## CALIFORNIA COASTAL COMMISSION

SUBJECT: STAFF RECOMMENDATION ON CITY OF SAN DIEGO MAJOR LCP  
AMENDMENT NO. 2-98B (North Bay Redevelopment Plan)

SYNOPSISSUMMARY OF AMENDMENT REQUEST

### **SUMMARY OF STAFF RECOMMENDATION**

Proposed Reaches for  
 Potential Bay-to-Bay  
 Canal

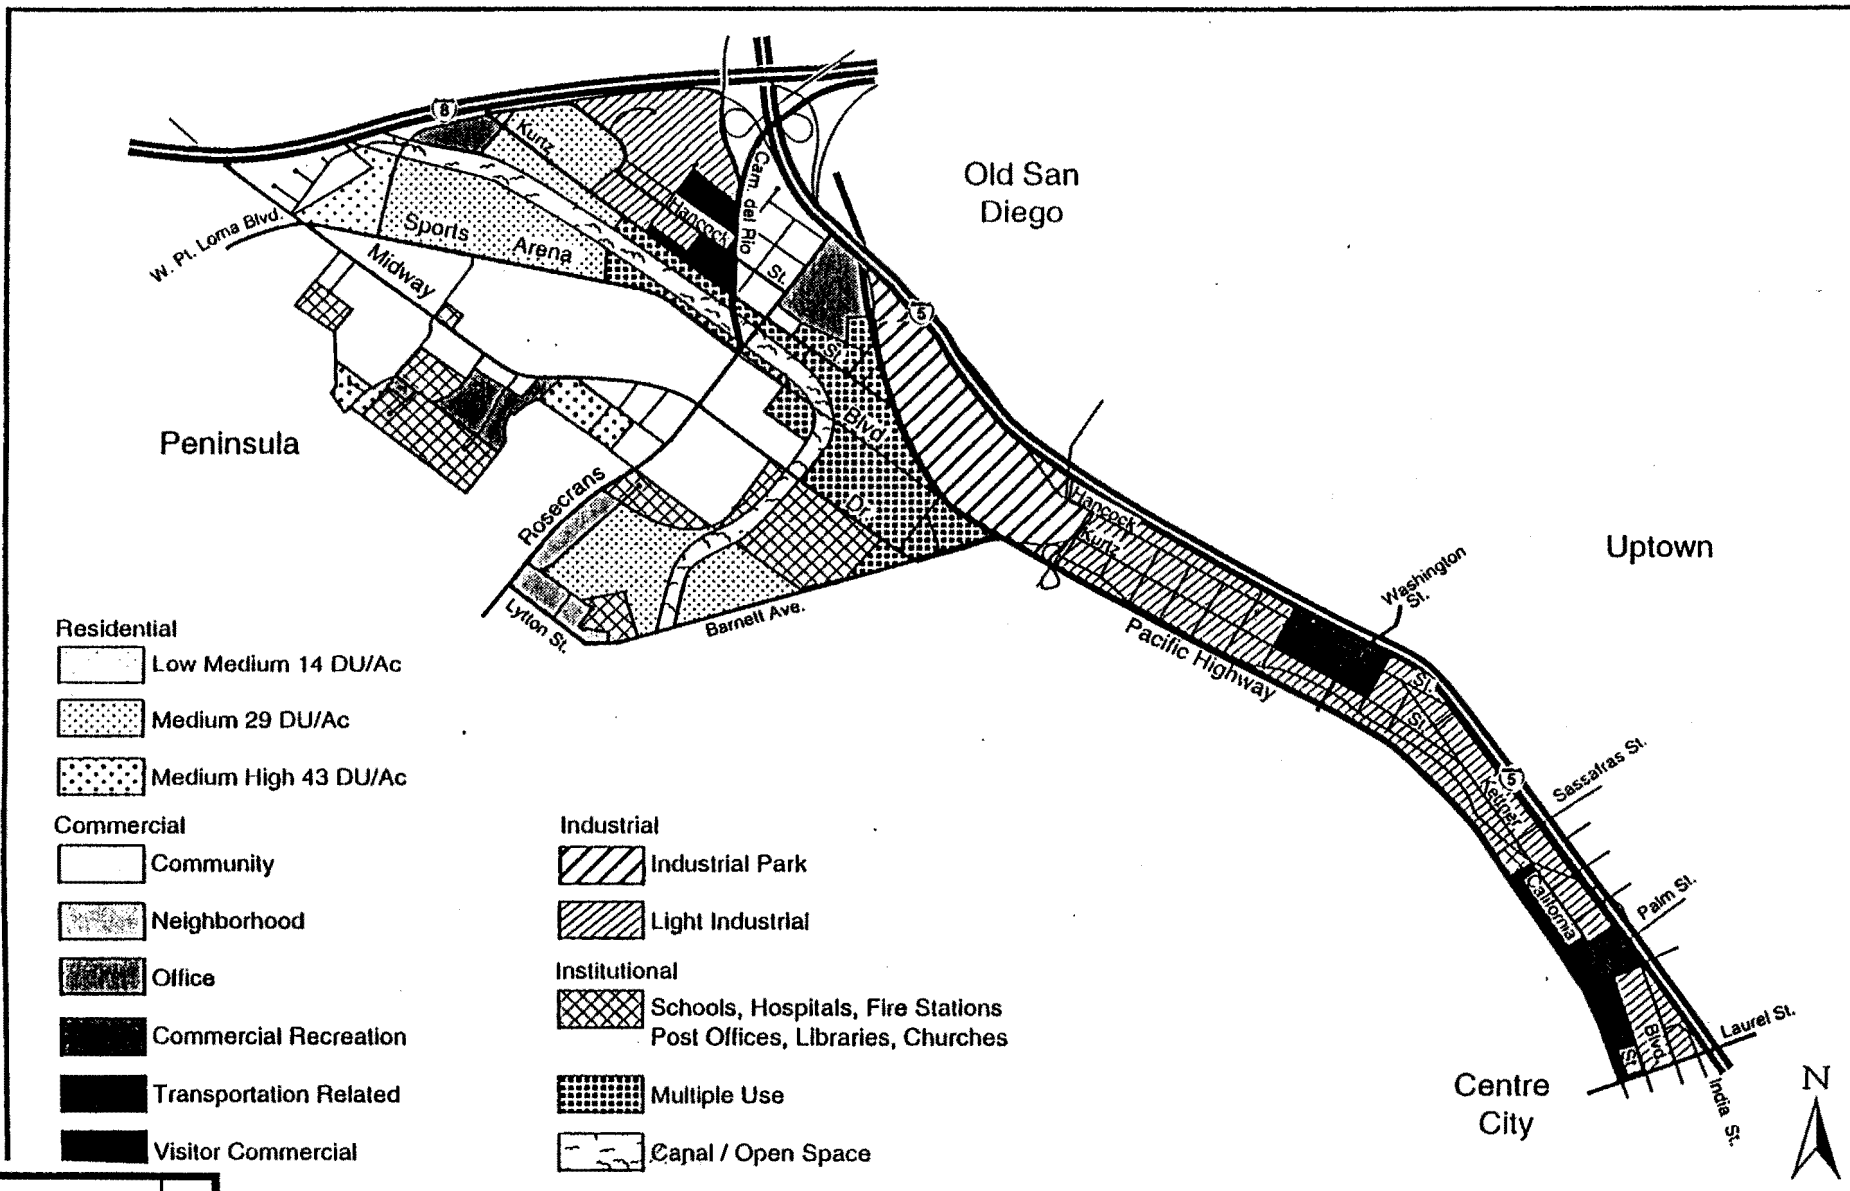
The canal alignment is conceptual at this time: and subject to further environmental assessment and amendments to the City's certified Land Use Plans. The most likely alignment is shown on the following figure. However, there are potential variations, particularly in Reach 1 (from the NTC channel to Rosecrans Street).

The proposed LUP amendment consisting of a redevelopment plan is unusual in that it encompasses several planning areas within the City of San Diego (reference Exhibit No. 1). A major component of the plan (Midway/Pacific Highway Corridor segment) is to lay the groundwork for acceptance of a bay-to-bay link (San Diego Bay to Mission Bay) which would consist of an approx. 200-foot wide long canal which is a little less than two miles long. The proposed waterway would be navigable by small hand powered watercraft (e.g., kayaks, canoes, outriggers) and by small motor craft (water taxis, trailerable boats). Several alignments for the canal have been considered and none has been selected as yet. However, the entire alignment including portions inside and outside the coastal zone is discussed in the proposed LUP revisions. Even though the Midway/Pacific Highway Corridor LUP which is the subject of this LCP amendment, includes only the portion of the canal which is located outside the coastal zone, the canal is referenced throughout the LUP as the bay-to-bay canal which infers construction within the coastal zone.

As described in the LUP, the general alignment would commence at the San Diego River flood channel just north of Interstate 8 and will run in a southeasterly direction between Sports Arena Boulevard and Kurtz Street exiting to the south at Barnett Avenue at the old Naval Training Center (NTC) premises. The canal is planned to consist of three reaches (reference Exhibit No. 3). Only a portion of Reach 1 and 2 are part of the subject LCP amendment and both reaches are outside of the coastal zone. The southern link to the San Diego Bay of the proposed canal is through NTC which is the subject of a redevelopment plan currently in progress. However, this area is not a part of the subject LCP amendment or redevelopment plan area. Reach 3 is within the coastal zone but lies within the certified Mission Bay Park Master Plan area and is not a part of the subject LCP amendment nor redevelopment plan area.

The In developing plans for the final canal segment, the goal is to locate this segment will occur is conceptually proposed to be located in the San Diego River flood control channel. The potential bay-to-bay canal would be constructed as a separate facility within the flood

control channel; a jetty separating the two channels would be required. The potential bay-to-bay canal would likely be parallel to the flood control channel along the southern rock jetty, and then cross north to enable water craft to exit the channel to the Pacific Ocean and/or Mission Bay. A gate or lock would will probably be needed to protect the bay-to-bay canal from flooding during storm events. However, until further environmental studies are completed, the development of plans for a canal connecting San Diego and mission Bays cannot be completed. Thus, this segment of the canal may not be realized.

### Reach 2

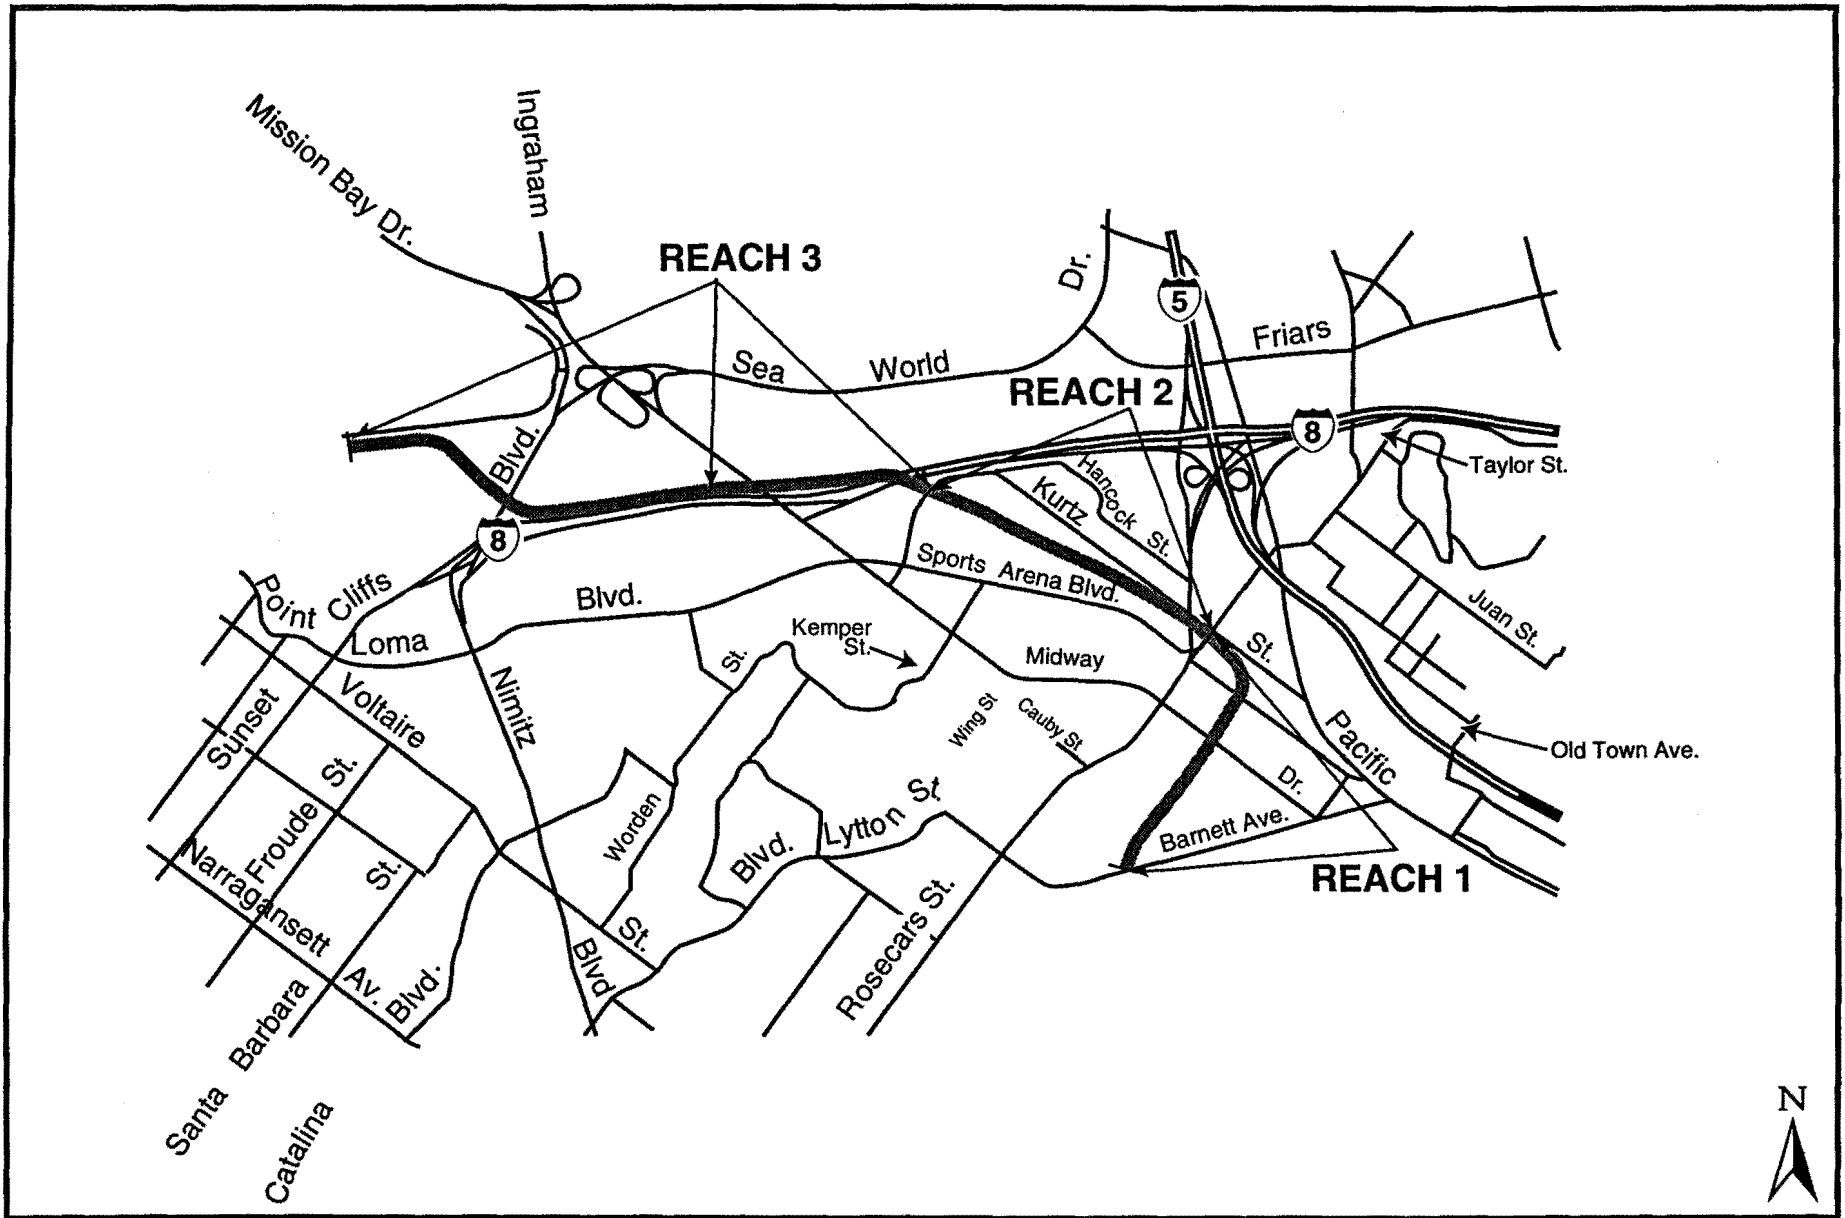
Reach 2 brings the canal from Rosecrans Street to the Interstate 8 freeway. Alignment options in this reach are few. The conceptual alignment is from Rosecrans Street, between Sports Arena Boulevard and Kurtz Street, which contains existing private commercial facilities, and then the City-owned Glasshouse Square retail area, Sports Arena, and Red Lobster retail centers. The canal would exit the community by flowing under Interstate 8 west of the Sports Arena. Since the parcels involved are, for the most part, large sites with numerous development possibilities, the canal can be sited anywhere within those parcels to best suit planned development.

# **Locations of Major Improvements** **Midway / Pacific Highway Corridor Community Plan** CITY OF SAN DIEGO • PLANNING DEPARTMENT

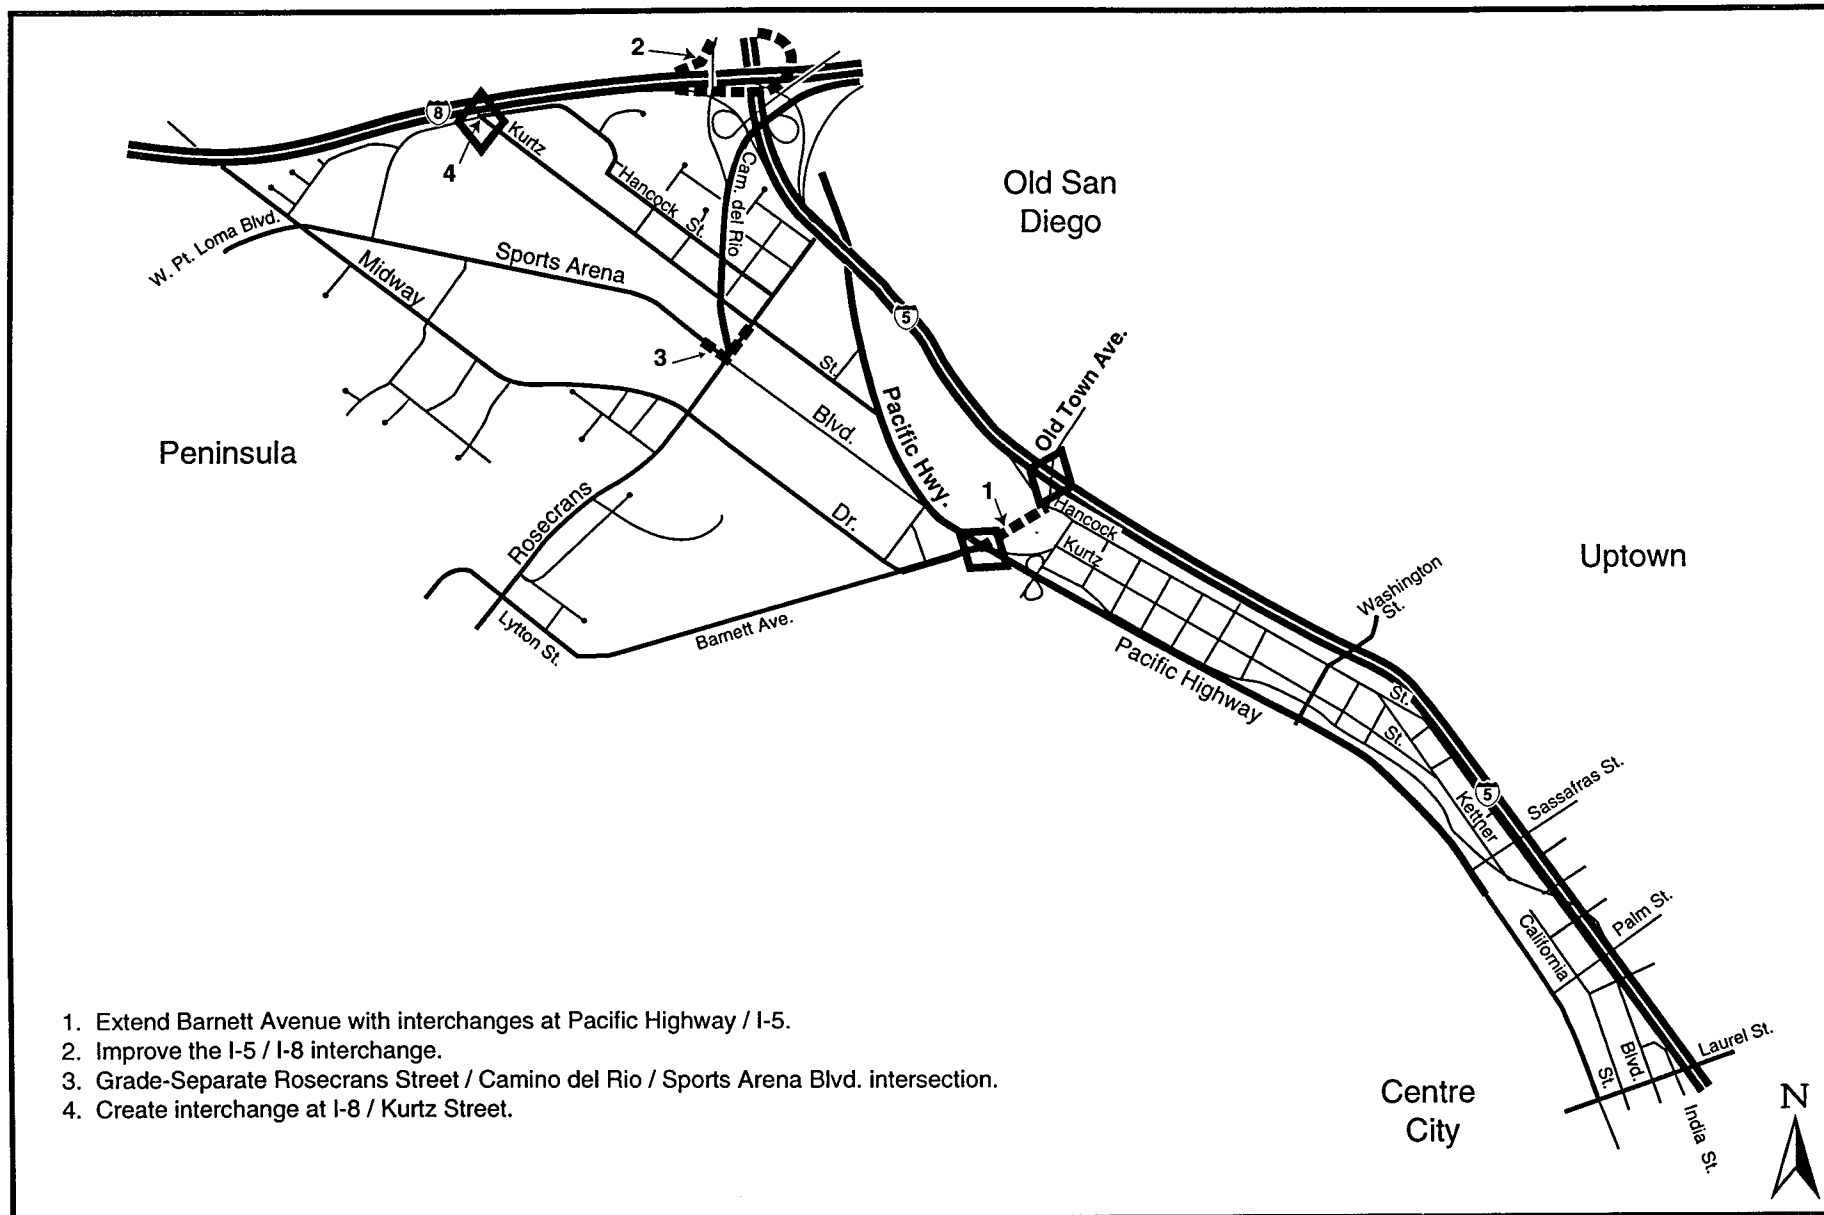
Amend Figure 20 on Page 90 to modify reference to tunnels under Rosecrans Street, to include option for bridge(s) to accommodate bay-to-bay canal.
